# City of Richmond

**Re: Request for Quotation 4215Q – Supply and Installation of Piles at Garry Point Park -  
Addendum Two (2)**

# ANODE DETAIL

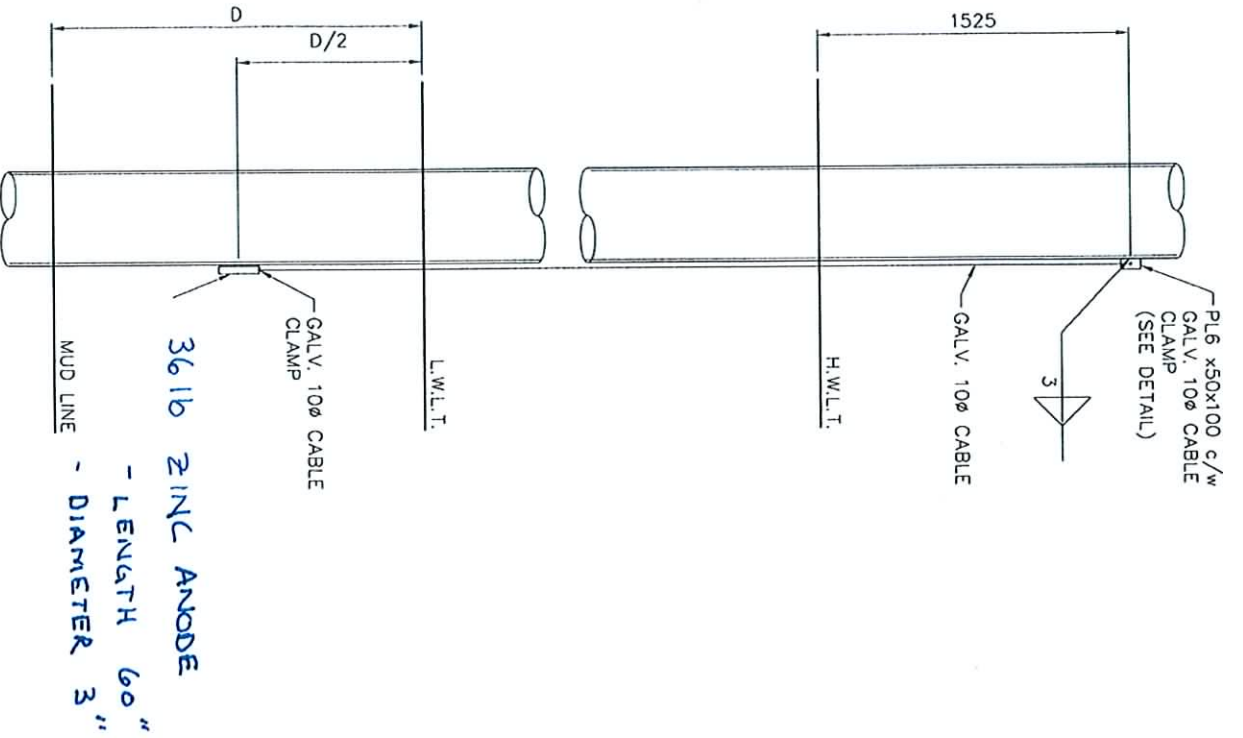
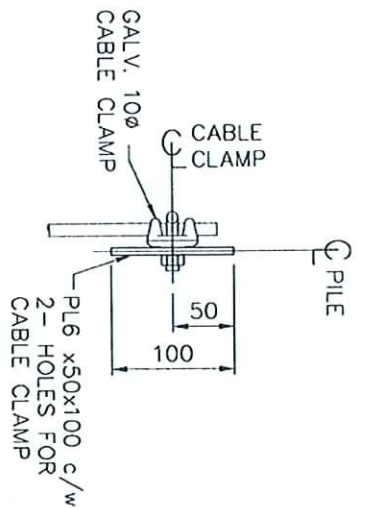
Q.1 What size/type of zinc anodes do you want for the cathodic protection?

A.1 The zinc anodes are a hanging type, cylindrical in shape at 60 inches long x 3 inches wide x 30lbs (or equivalent length and width with squared edges). They shall be hung from the pile top with steel cable allowing them to be inspected and/or changed out without the use of divers. The cable extends from the top connection to the anode. Please see the detail, appended to this Addendum.
